STAFF REPORT: 5/12/2021 MEETING
APPLICATION NUMBER: #21-7245
ADDRESS: 19505 CANTERBURY
HISTORIC DISTRICT: SHERWOOD FOREST
APPLICANT: JAMEY SNELL
PROPERTY OWNER: JAMEY SNELL
DATE OF PROVISIONALLY COMPLETE APPLICATION: 04/19/2021
DATE OF STAFF SITE VISIT: 4/27/2021

SCOPE: INSTALL FRONT WALKWAY AND STEPS

Figure 1, by Applicant: Location of steps and walkway.

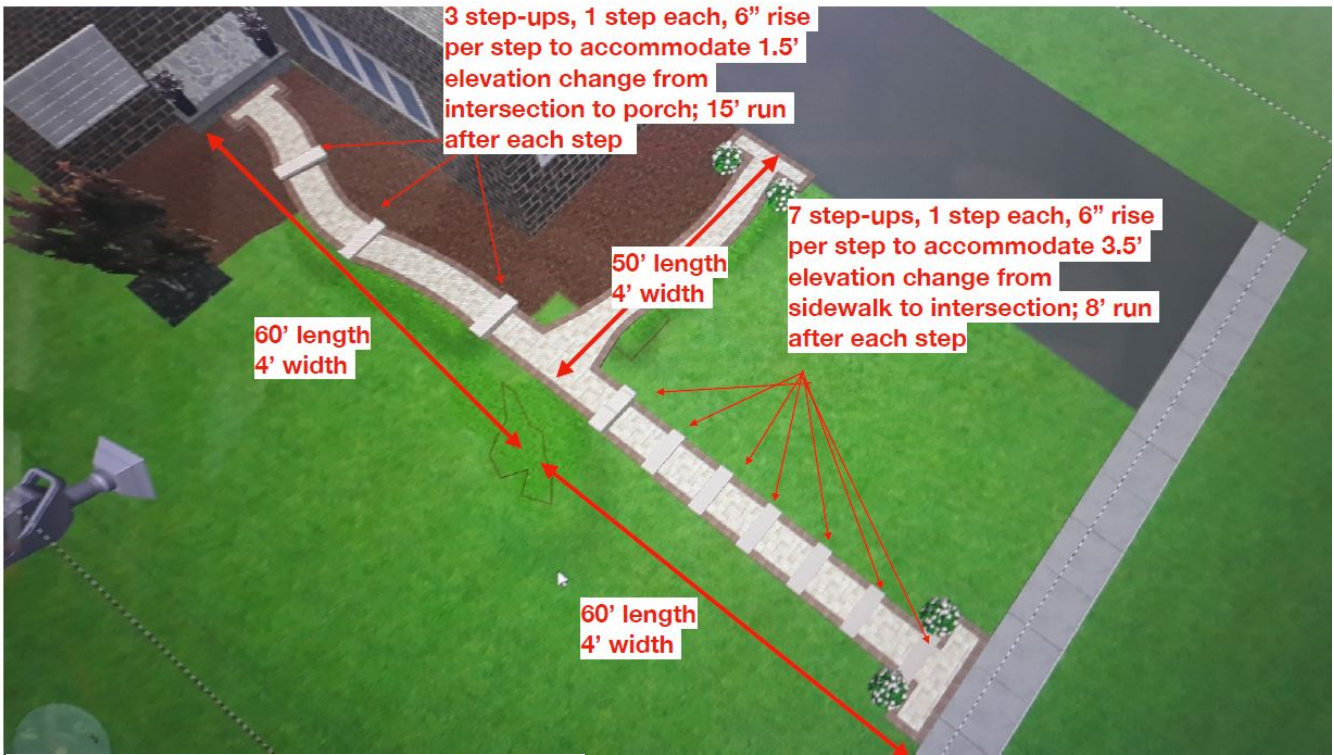
- Upon receipt of the application, Staff received the following additional information after inquiry to the applicant:
 - Measurements, locations of steps, count of steps/risers throughout the proposed walkway. (See Figure 1, above.)

- The applicant states that there is a 6-foot drop from the front entrance to the public walkway, Staff observed a less severe change of grade.

- Staff observed that the adjacent neighbor, with a similar slope and less distance, has installed a walkway from the front of the house to the sidewalk without use of any steps.
- Staff observed that the proposed design does not utilize the use of slopes and landings to reduce the need for steps over the length of the 60-foot length of the walkway, potentially reducing the quantity of steps proposed.
- Staff could find no historic precedents for a series of separated risers in a flat walk for such a property.
- Staff observed that spreading steps over the length of the walkway can cause several sets of trip-hazards if not properly lit or obscured by snow or leaf debris.

- While the *location* and *width* of the proposed walkways are an appropriate installation, it is Staff's opinion that the *spread of the use of steps*, and the material use of *colored, composite concrete pavers* are not an appropriate application of the walkway's installation as described in the Elements of Design for Sherwood Forest HD's description of the relationship of "significant landscape feature and surface treatments":

It is staff's opinion that the work proposed, other than the use of composite concrete material with widespread use of single steps and irregular meander, retains and preserves the historic character of the building, its site, and setting. Staff therefore recommends that the Commission issue a Certificate of Appropriateness as the proposed work meets the Secretary of the Interior's Standards for Rehabilitation.

- Applicant work with Staff to issue a more appropriate material than the composite concrete block for the pavers.
- Applicant work with Staff to adjust the design of the walkway with the following changes:
 - Consolidate steps to a single or dual occurrence.
